Westbard Sector Plan, Work Session #4

Westbard Sector Plan, Work Session #4

ERRATA

Figure 3.1.1: Proposed Zoning Map – Westbard Avenue District

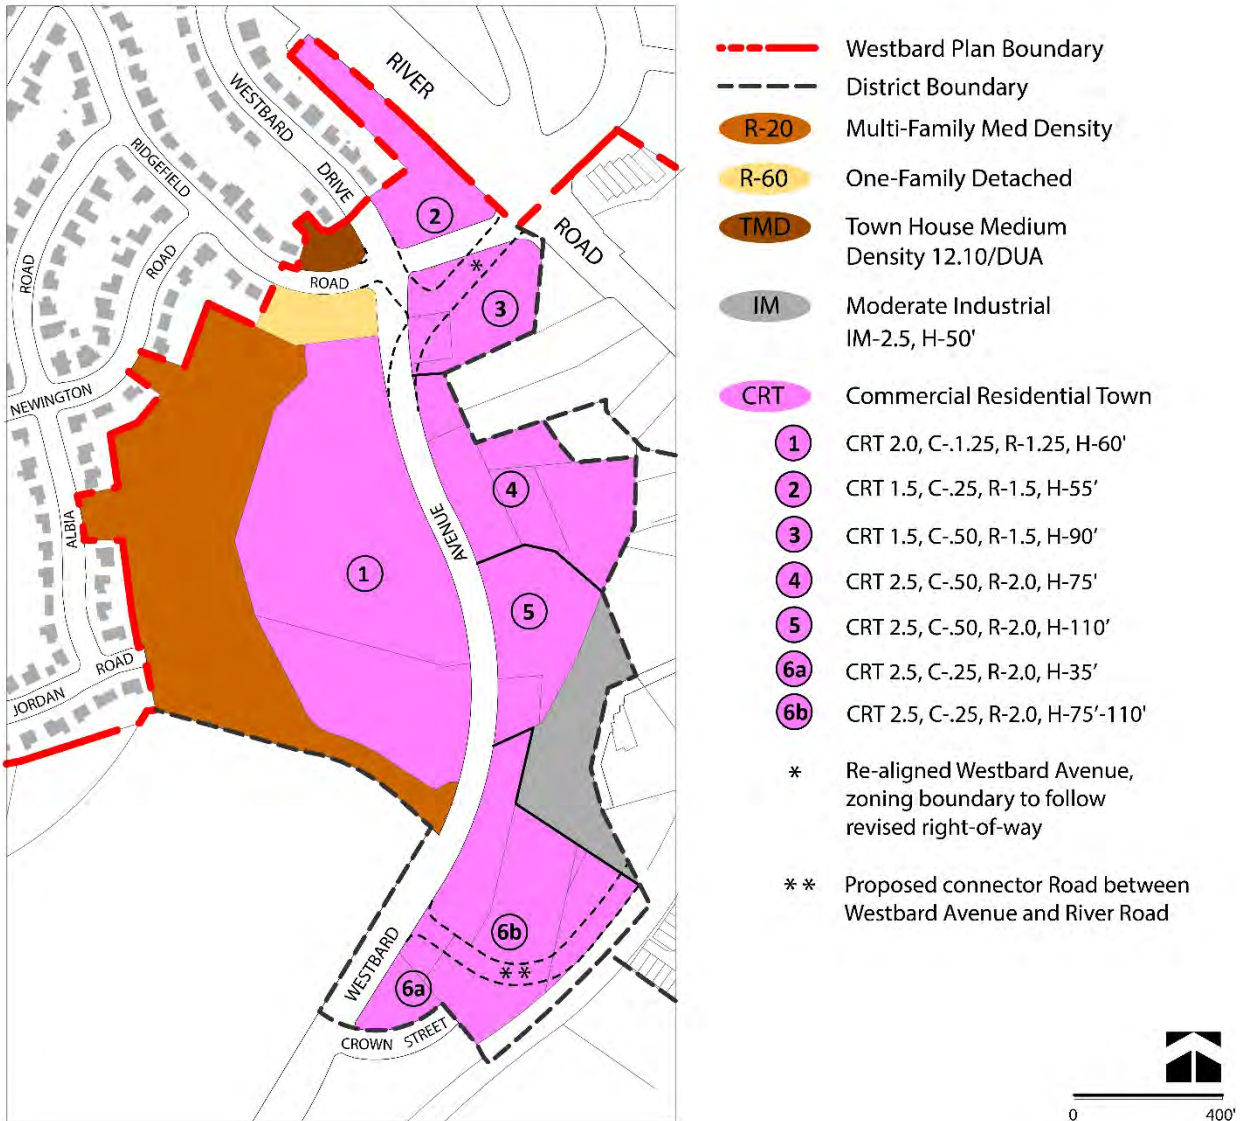
- Westbard Avenue District Site 2 (Figure 3.1.1 Proposed Zoning Map – Westbard Avenue District) parcel A, - the plan strongly encourages residential as the predominant use for this parcel. Commercial uses are strongly discouraged on this site.

- Westbard Avenue District Sites 6a and 6b (Figure 3.1.1 Proposed Zoning Map – Westbard Avenue District) parcels 466, 519, 510 and 576, - Heights of buildings to range between 35 feet at the south end of the site to 110 feet at the north end. Height transitions to be gradual, avoiding abrupt changes in height. The proposed connector street between Westbard Avenue and River Road to be located as far north as practical, and the heights south of this road to be a maximum of 35 feet. The height transitions to be detailed and illustrated more fully in the Westbard Sector Plan Design Guidelines.

- Westbard Avenue District Sites 6a and 6b (Figure 3.1.1 Proposed Zoning Map – Westbard Avenue District) parcels 466, 519, 510 and 576, - At the time of redevelopment, residential portions of the site greater than 35 feet in height must provide a minimum of 25% affordable housing units, including a minimum of 15% moderately priced dwelling units and 10% workforce housing units.

Figure 3.2.1: Proposed Zoning Map – River Road Corridor

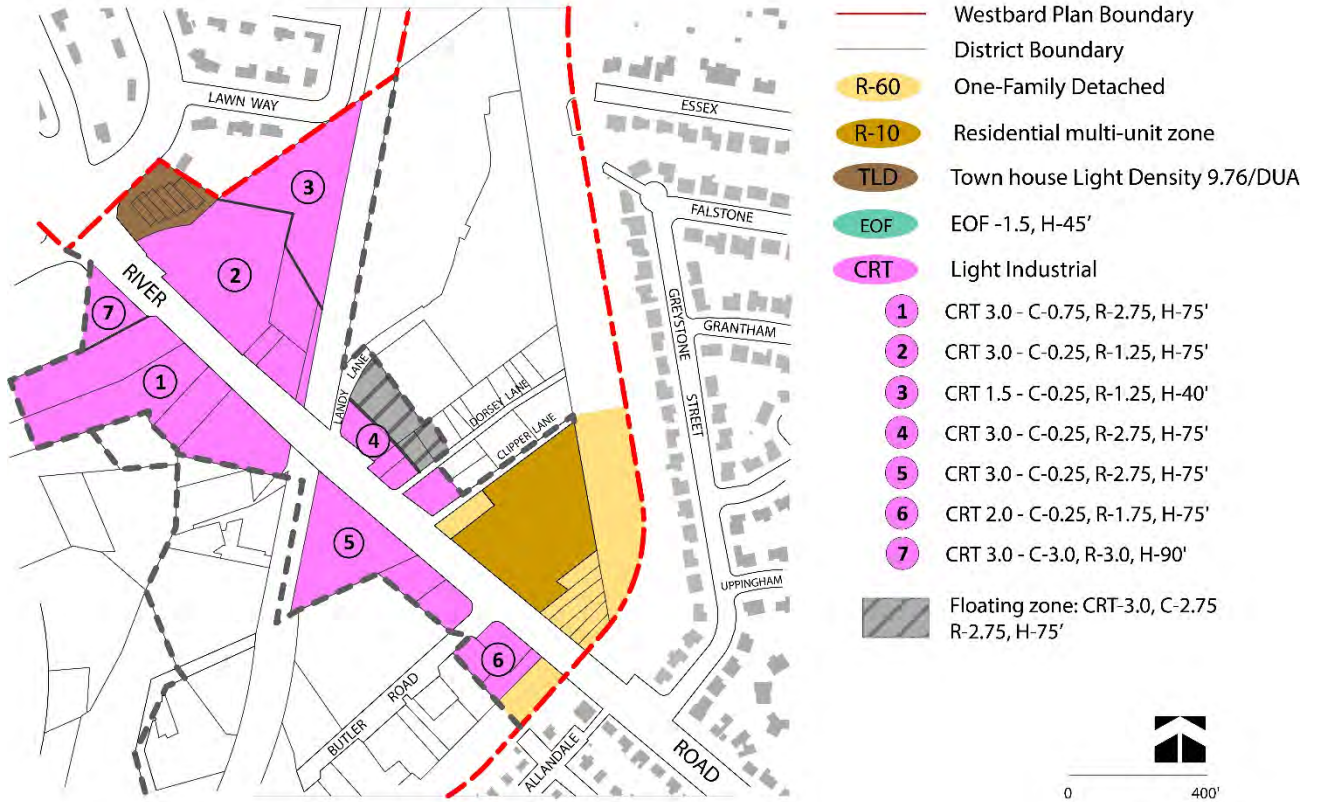
- River Road Corridor Site 2 (Figure 3.2.1 Proposed Zoning Map – River Road Corridor), parcels 029, 055, 082 and 109 - the proposed 75 feet of height, should only be allowed if future development includes the priority benefit incentive of a recommended green space along Willett Branch (See page 70: Community Open Space along Willett Branch). Future development should be placed closer to the Capital Crescent Trail, where feasible. This condition assumes assemblage of sites 2 and 3.
